Access Compliance Report

Public Rights-of-Way

(Curb Ramps)

Intersection ID: 6886	Main Street: JOHN_RUSSELL_DR	Cross Street: WINGDALE_DR	Location: SW
ADA ID: 5892035E595F	Ramp Type: Perp	Initial Pass/Fail: Fail	Overall Compliance: No
Codes/Mitigation Info/Possible Solution		Field Measurements/Component Compliance	
Severity Score: 10

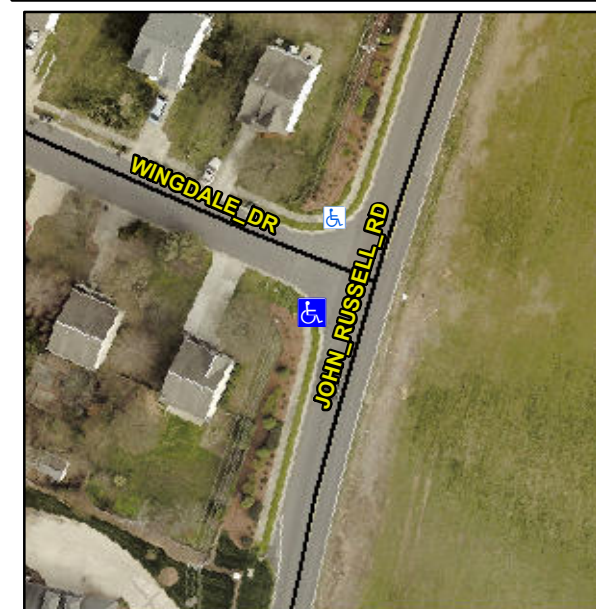
Not Found, R304.5.1, R304.5.3

Compliance	Description	Data	Compliance	Description	Data
N/A	Ramp Length (in)	47.0	Yes	Ramp Slope (%)	5.9
No	Ramp Width (in)	47.0	No	Ramp XSlope (%)	3.0
N/A	Flare Type LT	N/A	N/A	Flare Type RT	N/A
N/A	Flare Slope LT (%)	N/A	N/A	Flare Slope RT (%)	N/A
N/A	Flare Traversable LT?	N/A	N/A	Flare Traversable RT?	N/A
N/A	Landing Length (in)	N/A	N/A	DWS Provided?	N/A
N/A	Landing Width (in)	N/A	N/A	DWS Contrast?	N/A
N/A	Landing Slope (%)	N/A	N/A	DWS Length (in)	N/A
N/A	Landing X Slope (%)	N/A	N/A	DWS Full Width?	N/A
N/A	Landing Curb? (Y/N)	N/A	N/A	DWS Offset (in)	N/A
N/A	Shared Landing?	N/A			
N/A	Gutter Ponding?	N/A	N/A	Gutter Slope (%)	N/A
N/A	Gutter Lip Ht (in)	N/A	N/A	Gutter X Slope (%)	N/A
N/A	Painted X Walk1?	No	N/A	Painted X Walk2?	N/A
	X Walk 1 Direction	To NE		X Walk 2 Direction	N/A
N/A	X Walk 1 Width (in)	N/A	N/A	X Walk 2 Width (in)	N/A
	X Walk 1 Slope (%)	3.3		X Walk 2 Slope (%)	N/A
	X Walk 1 X Slope (%)	5.2		X Walk 2 X Slope (%)	N/A

Remove & Replace Entire Ramp.
